N3381A-02

S E R V I C E N O T E

N3381A PNA Microwave Network Analyzers

Figure 1: A3 Front Panel Interface Board Assy without the Bracket

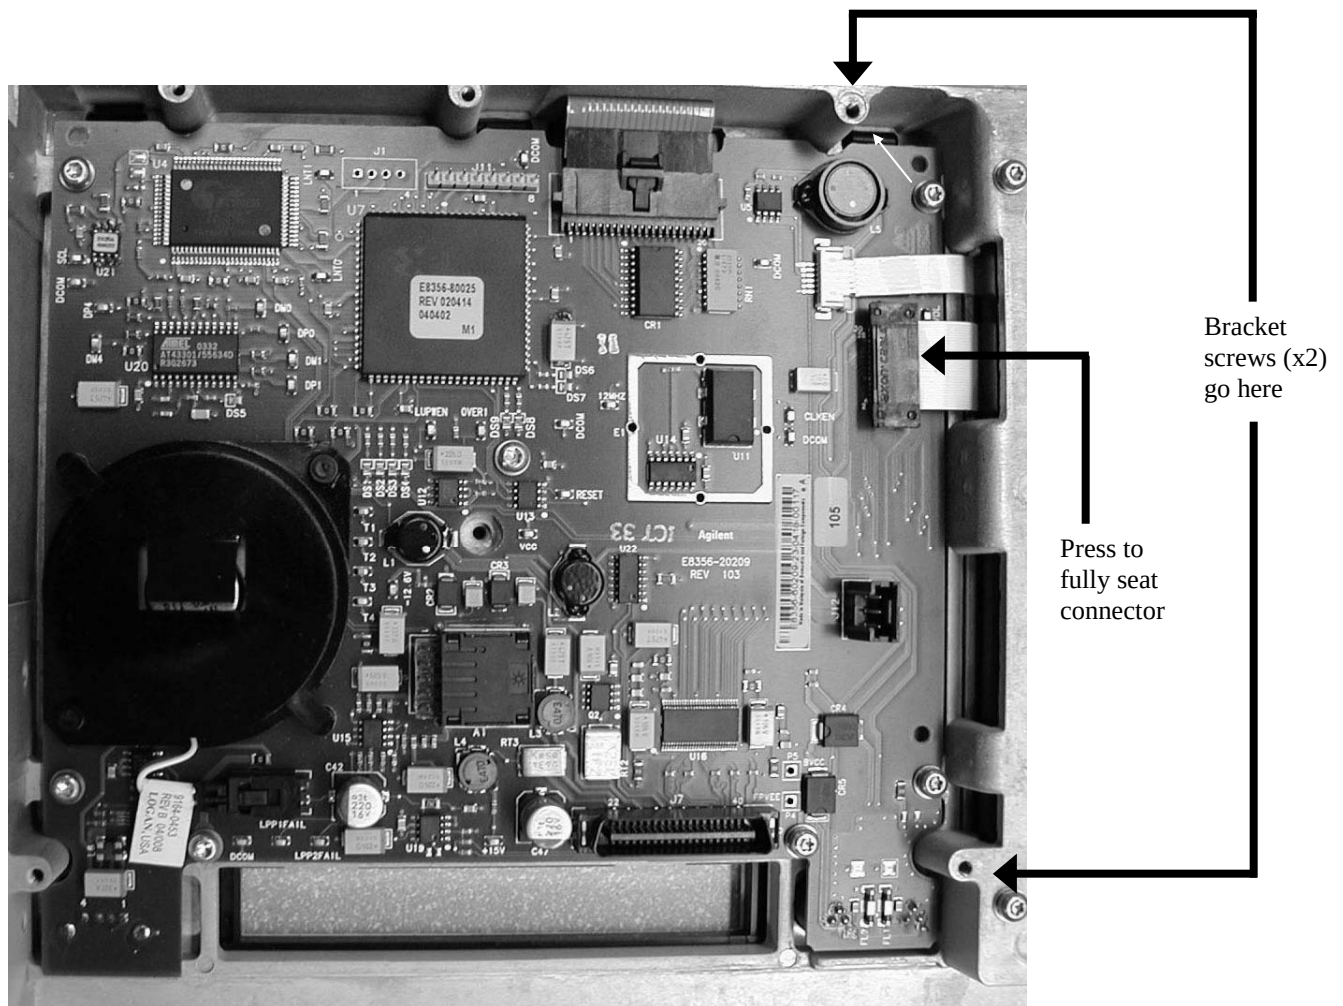
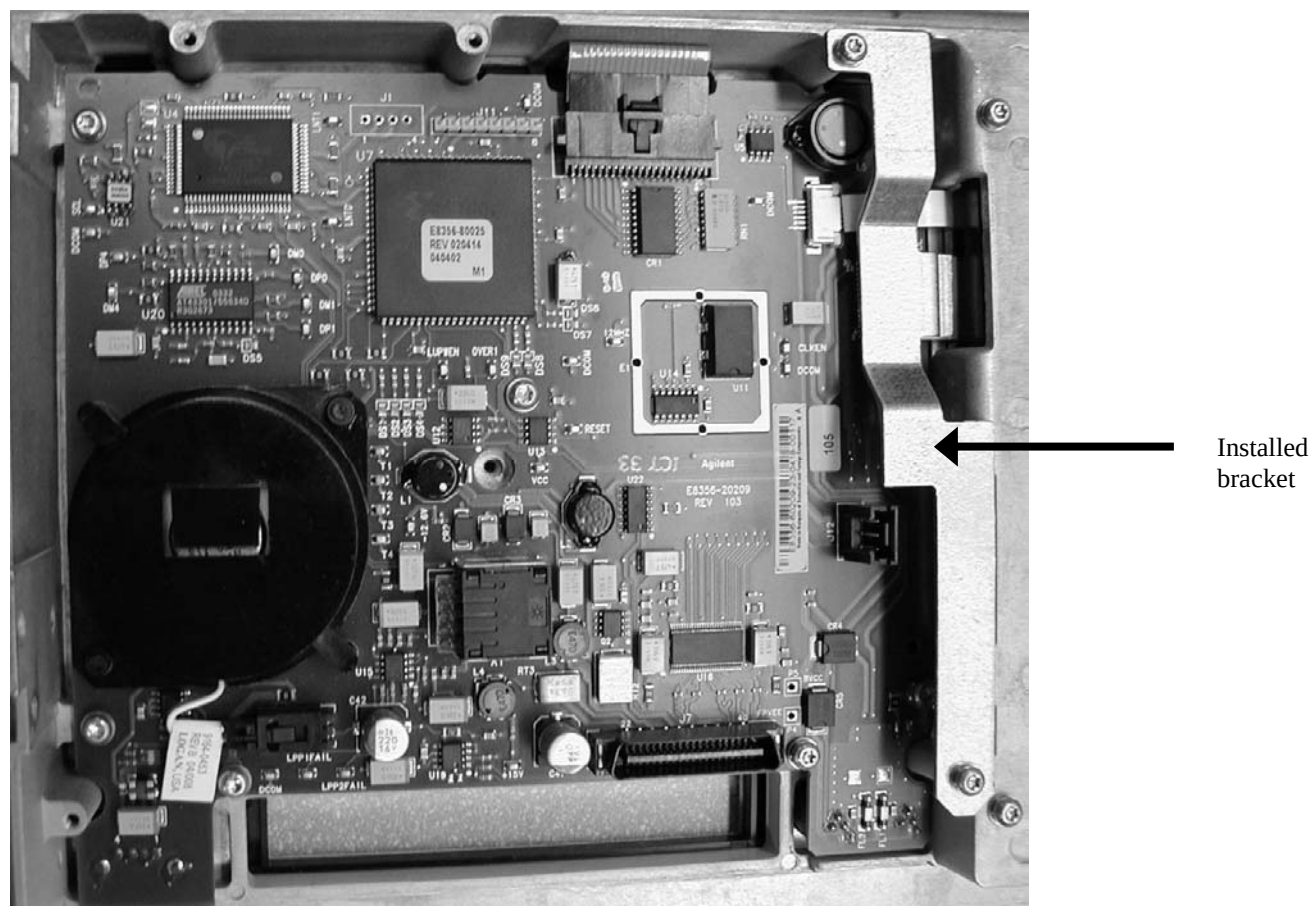
A connector of the ribbon cable (Agilent part number 8120-8409) that joins the front panel display to the front panel interface board can loosen, causing a display failure, unless a new bracket is installed. Because the failure rate has been very low, it is recommended that the bracket be installed only when there is an additional reason to remove the PNA front panel.

1. Refer to Figure 1 in this document:
 - Press down firmly on the ribbon cable's black connector.
 - Locate the two tapped holes for the bracket screws.
2. As shown in Figure 2 in this document, position the bracket so that its holes line-up with the two holes you located in the previous step.
3. Hand-start the two screws, and then torque both to 9 in-lbs.
4. Reinstall the PNA Front Panel by following the Service Guide instructions in the "Replacement Procedure." This is located on the same page as the "Removal Procedure" used previously in step 7.
